Addendum #1

Project Name: Indiana State University – Dreiser Hall Renovation

Project #: 19052

Date: June 12, 2020

1 Floor Plan
Basement Demolition Plan
D1.00 1/8" = 1'-0"

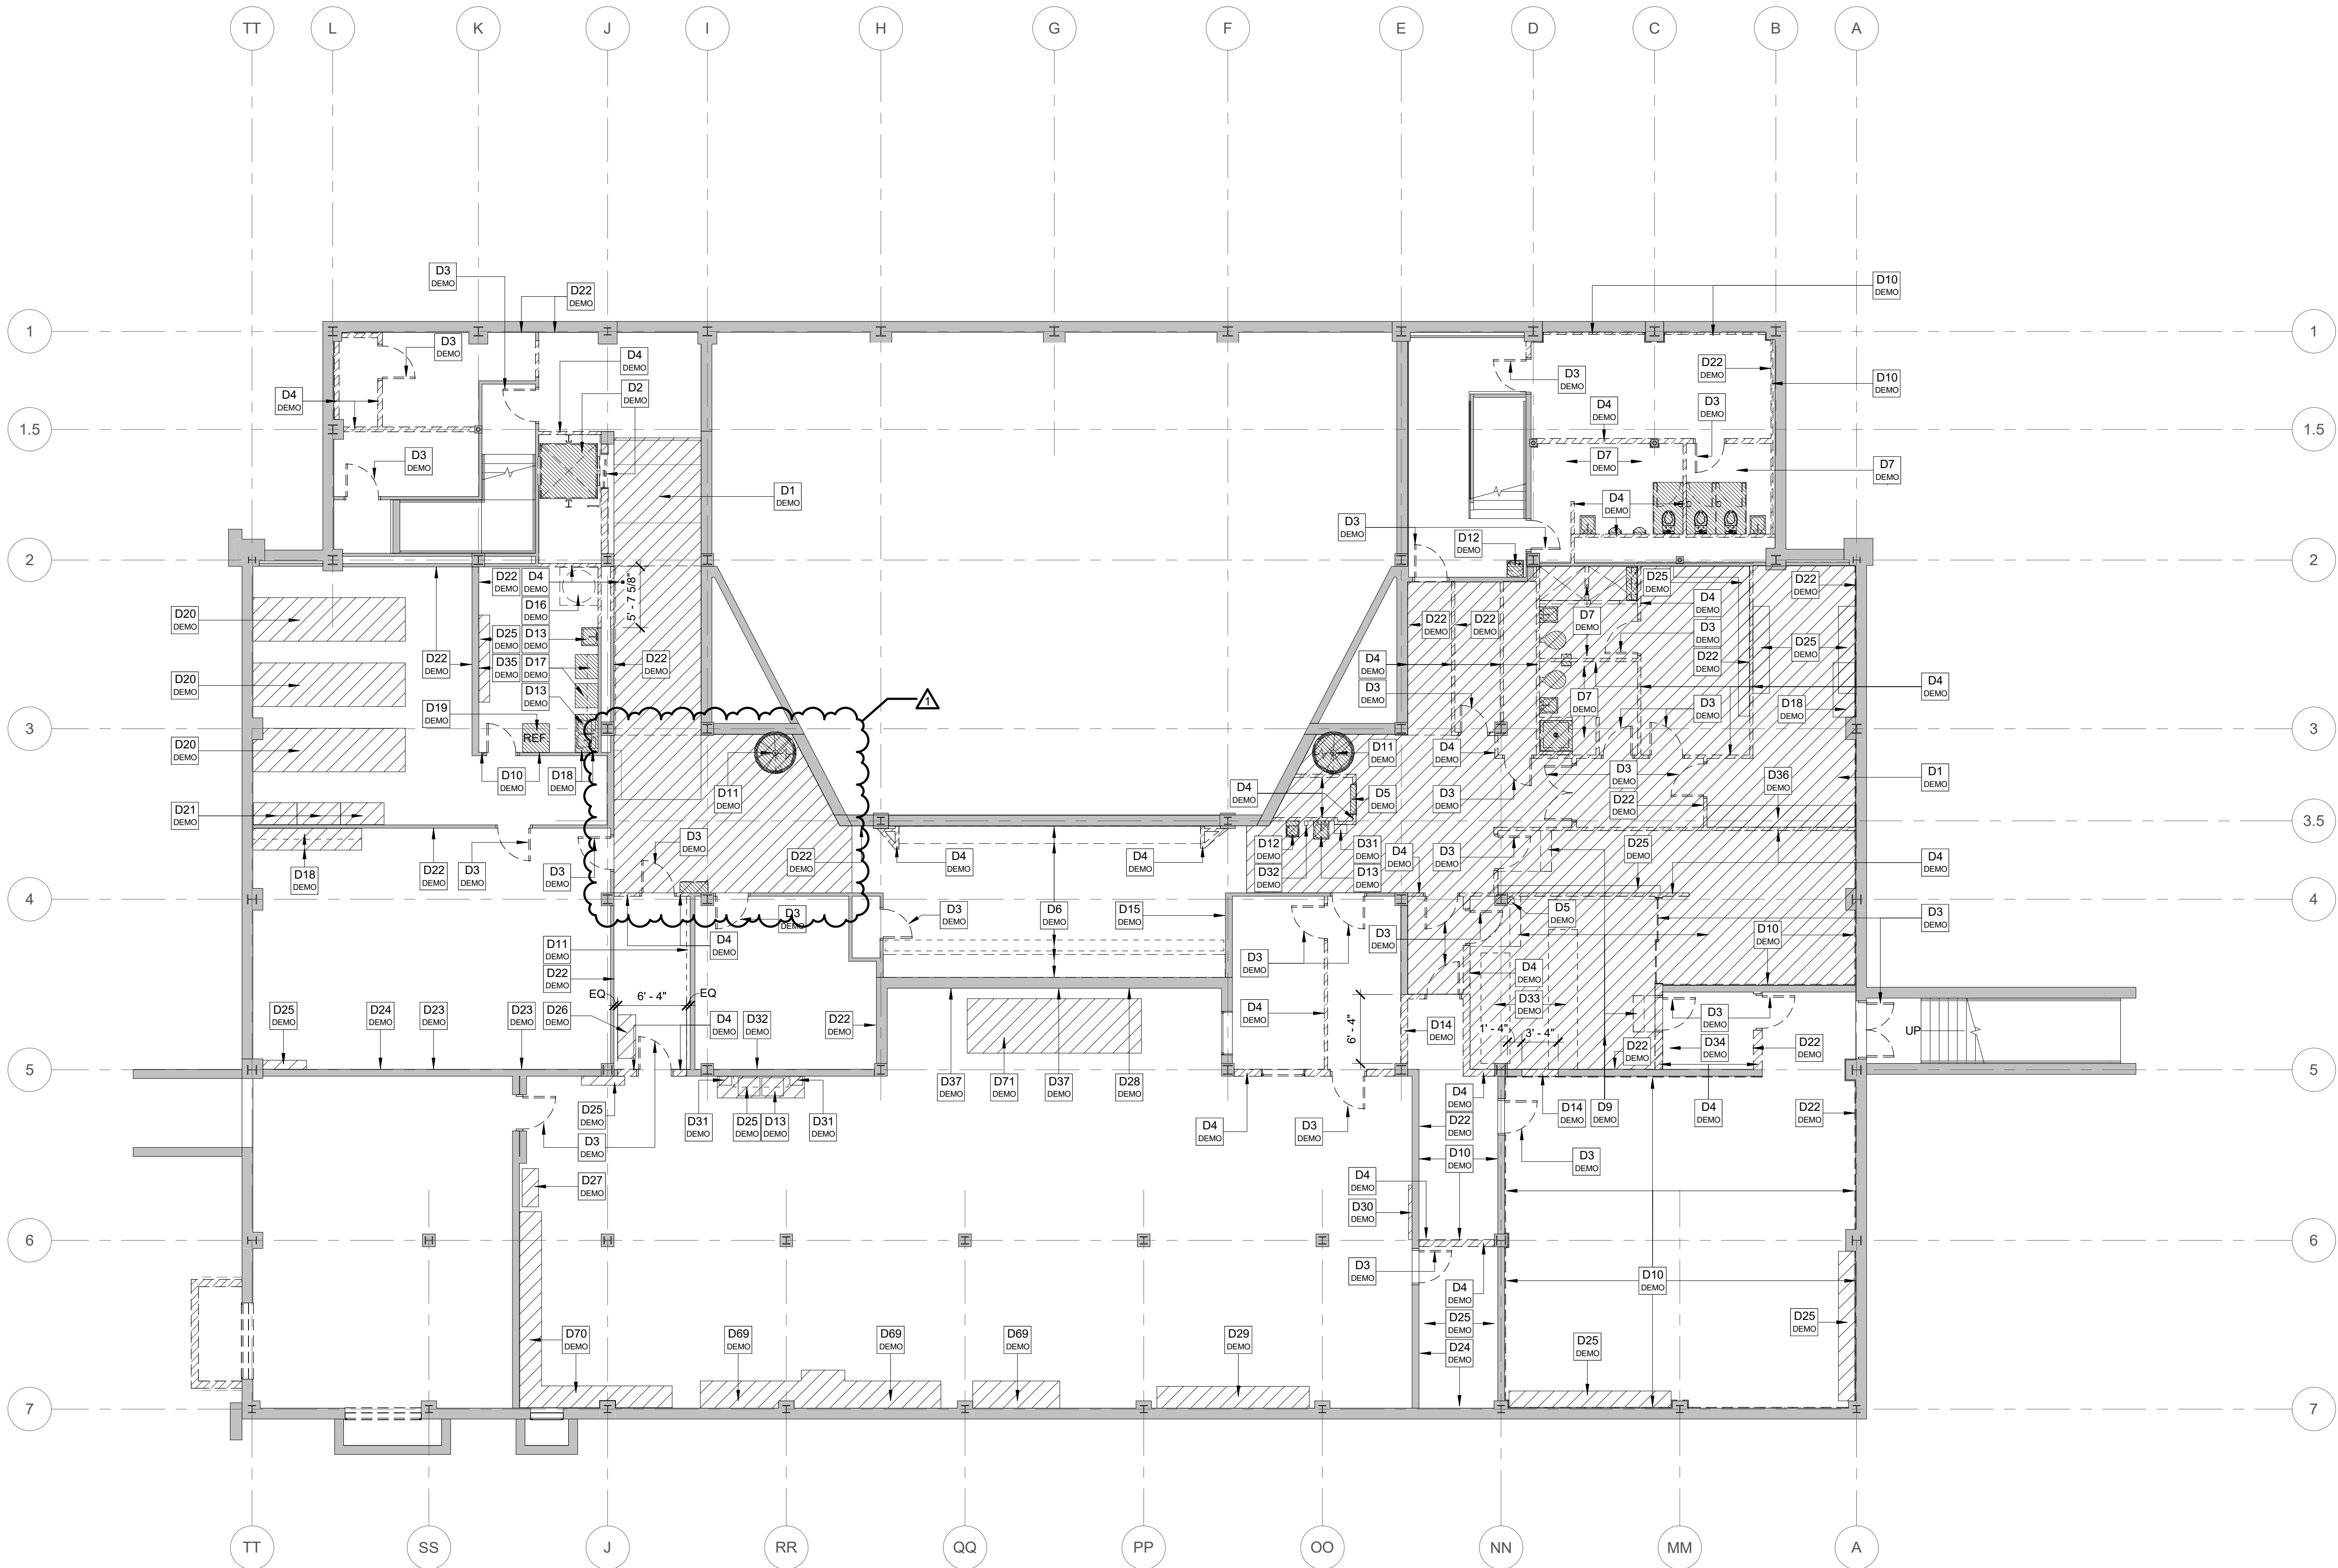
3. Sheet D1.00 – Basement Demolition Plan

- A. Reissue sheet – see clouds

1 Floor Plan
Basement Plan
A1.00 1/8" = 1'-0"

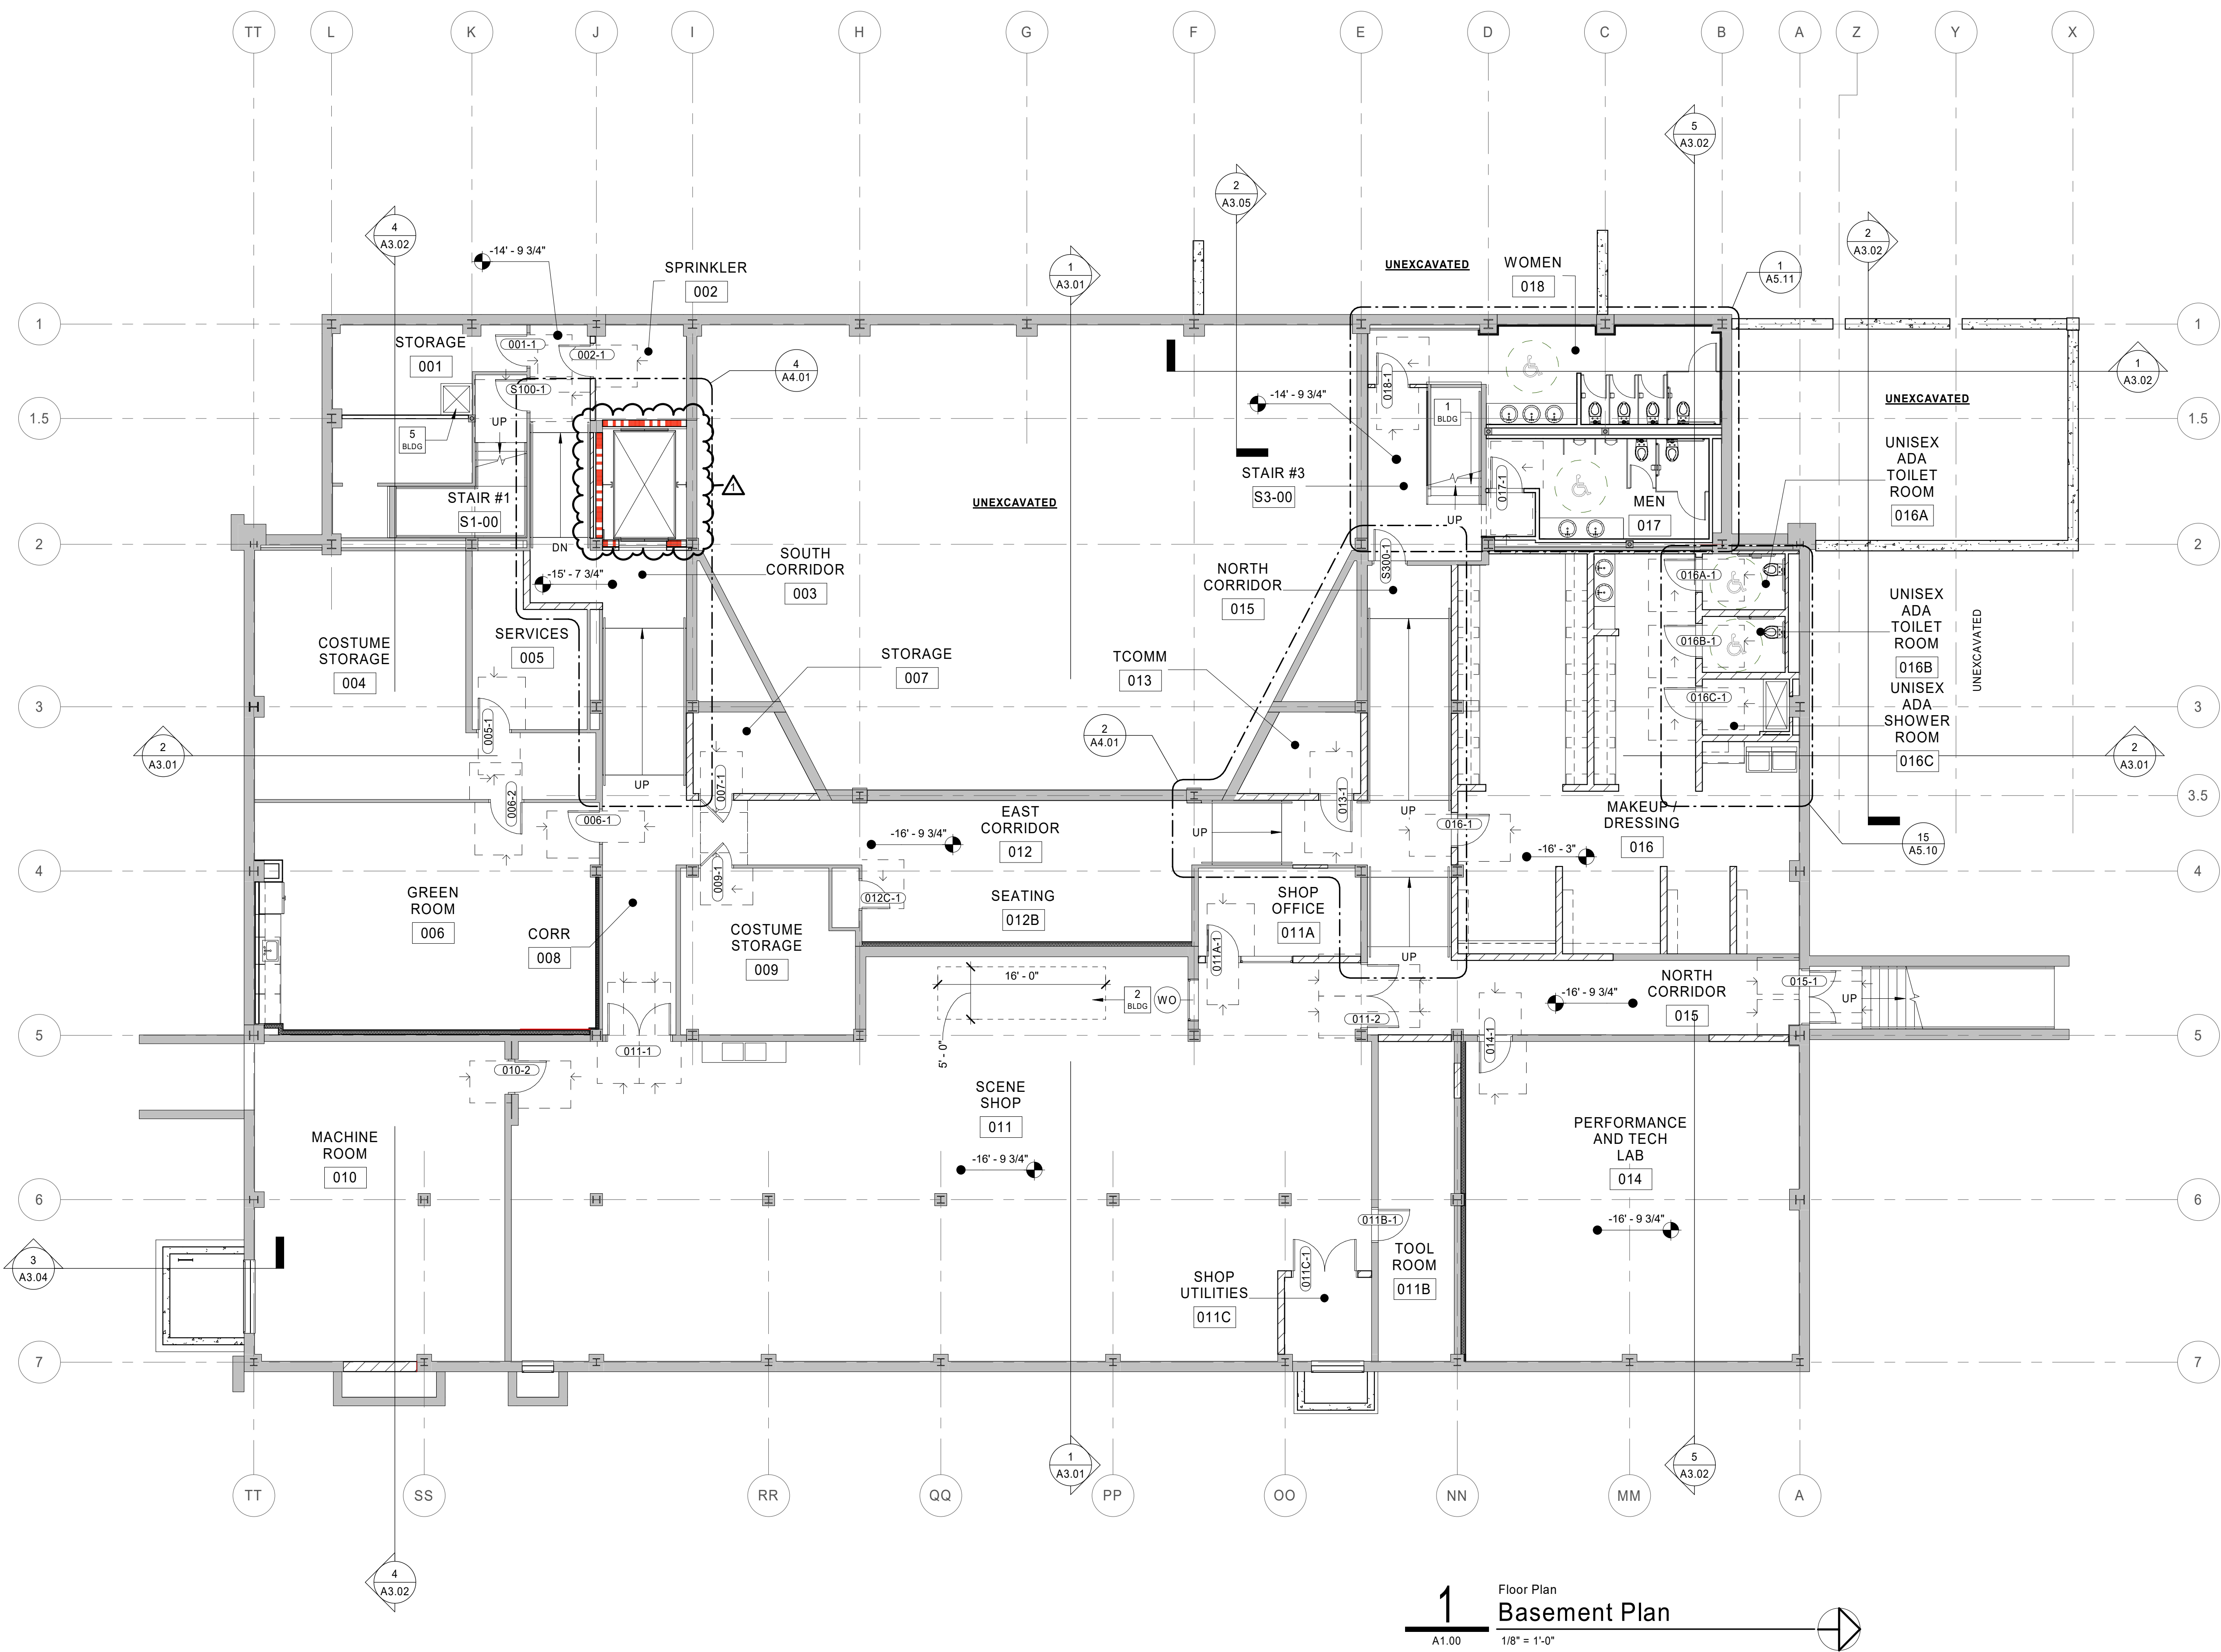
4. Sheet A1.00 – Basement Floor Plan

- A. Reissue sheet – see clouds
B. Add rated wall indicators.

1 Floor Plan
Basement - Dimension Plan
A1.00A 1/8" = 1'-0"

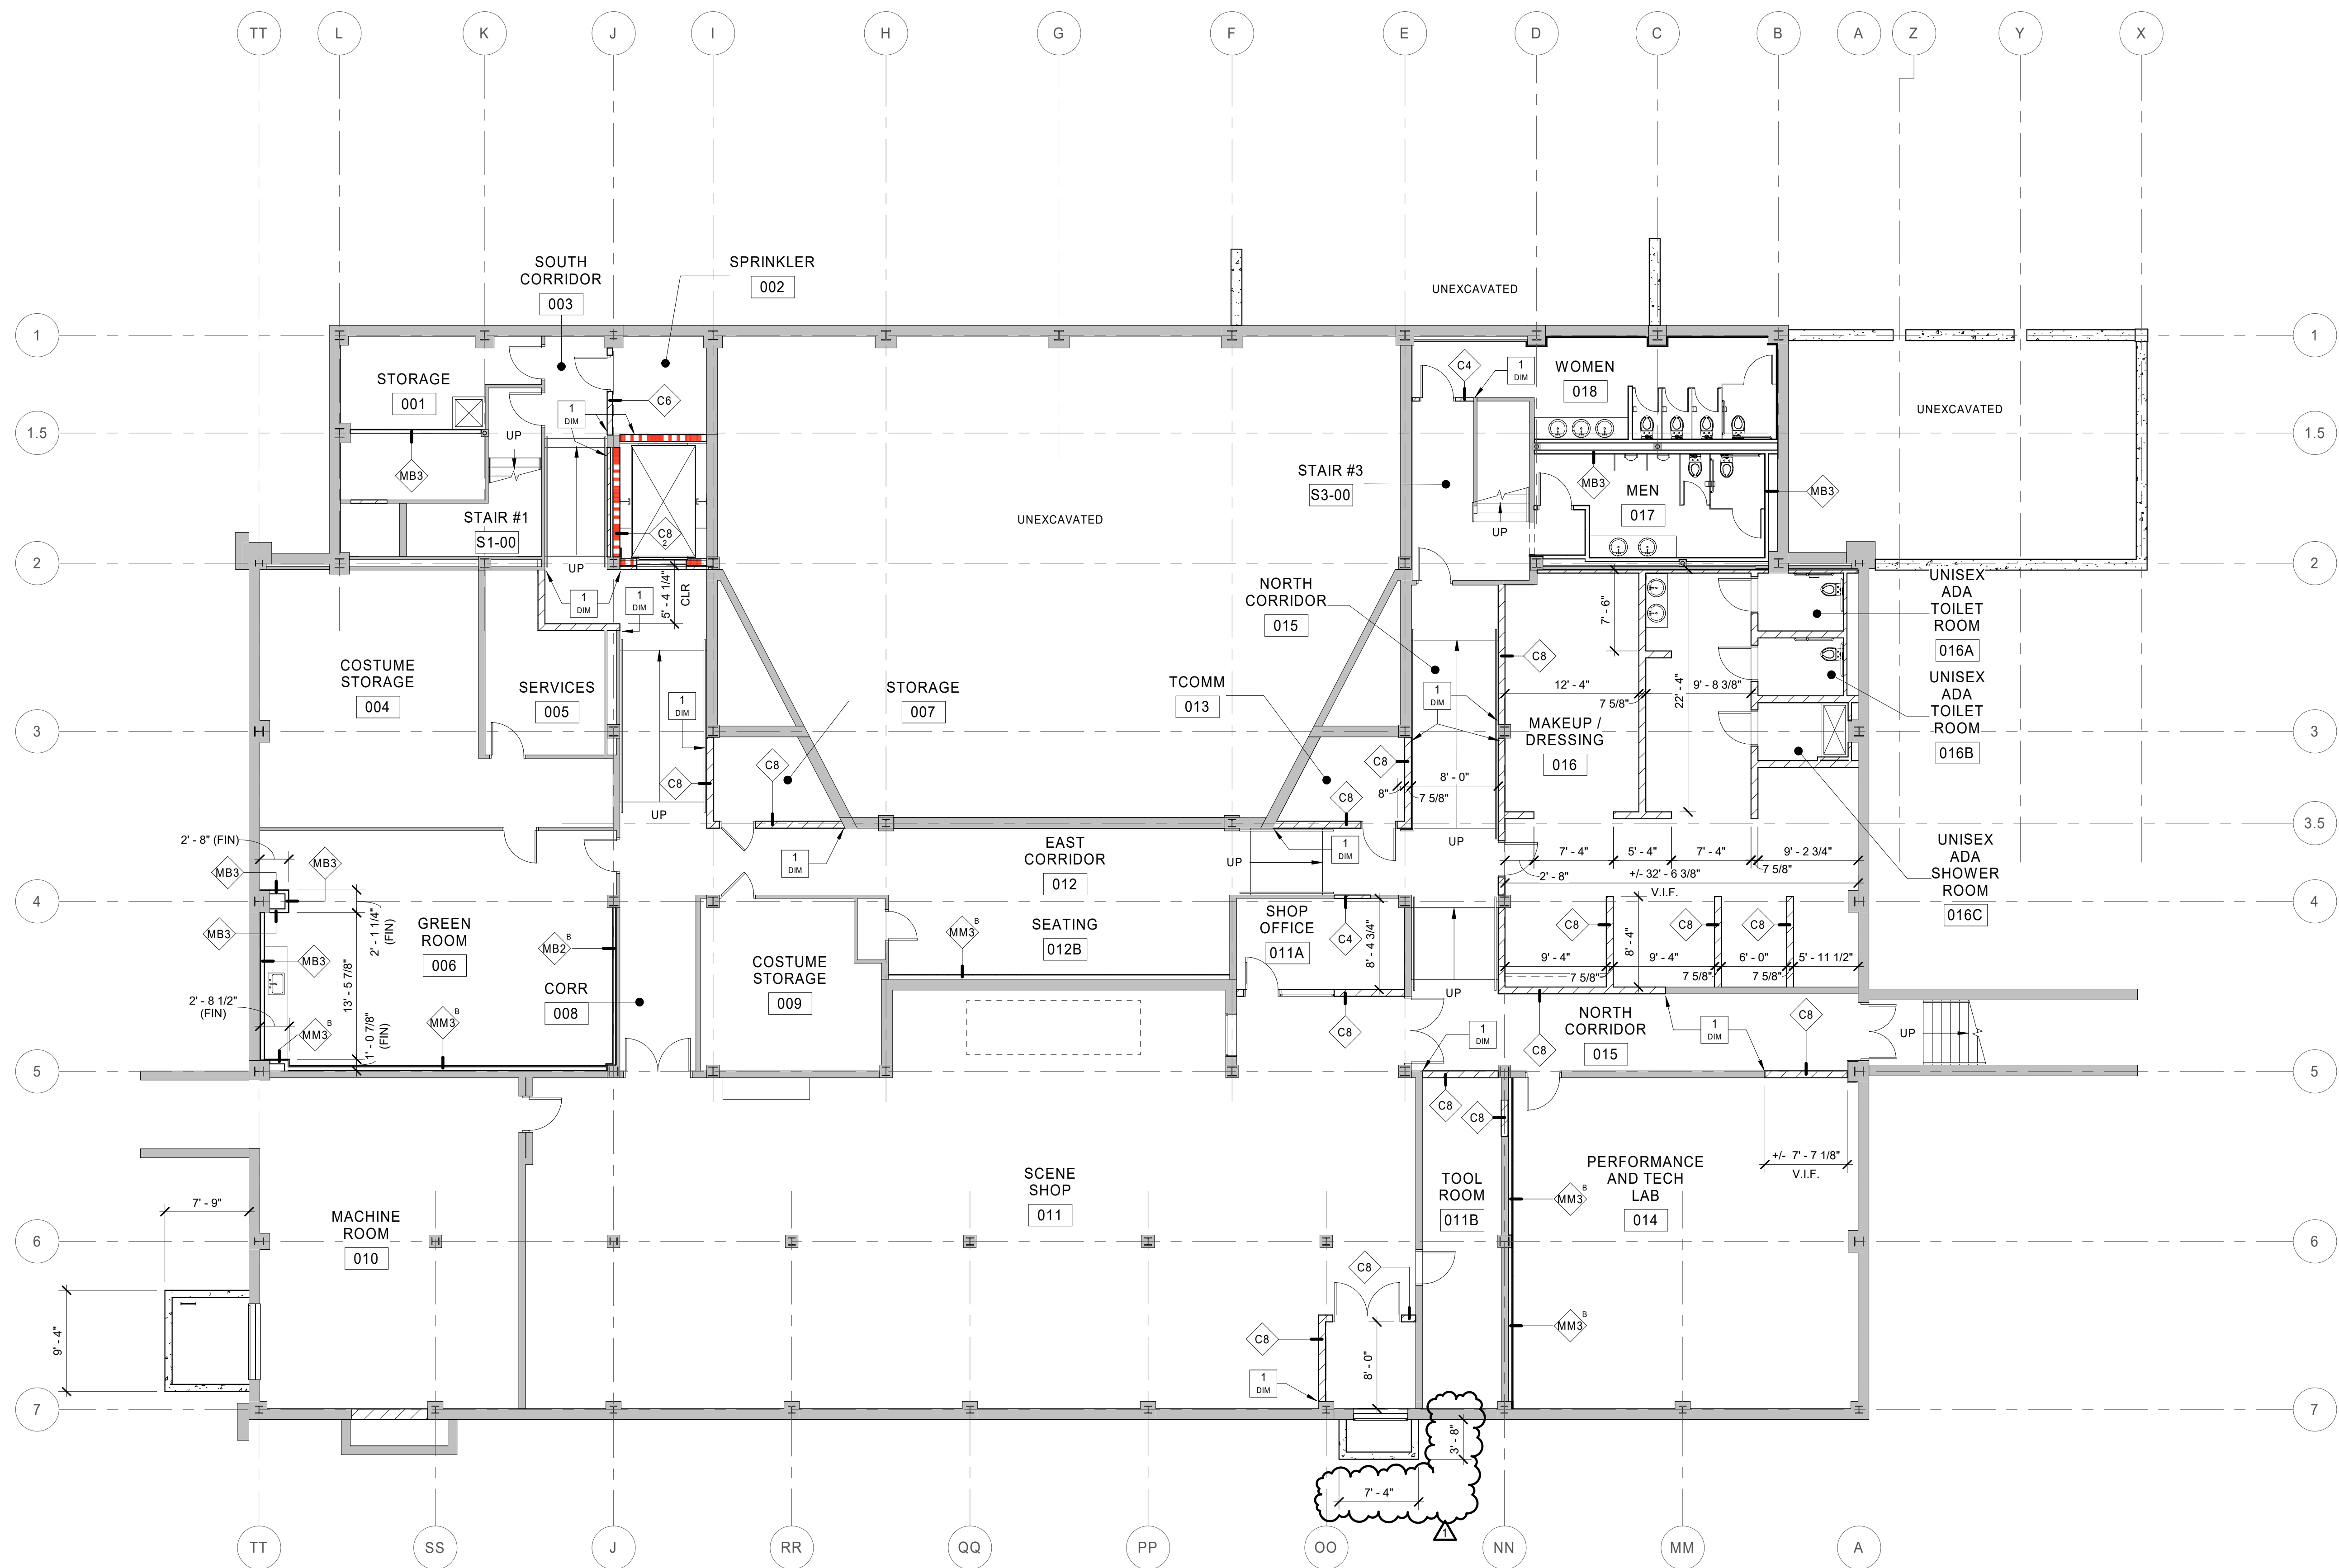
5. Sheet A1.00A – Basement Dimension Plan

- A. Reissue sheet – see clouds
B. Update wall tags.
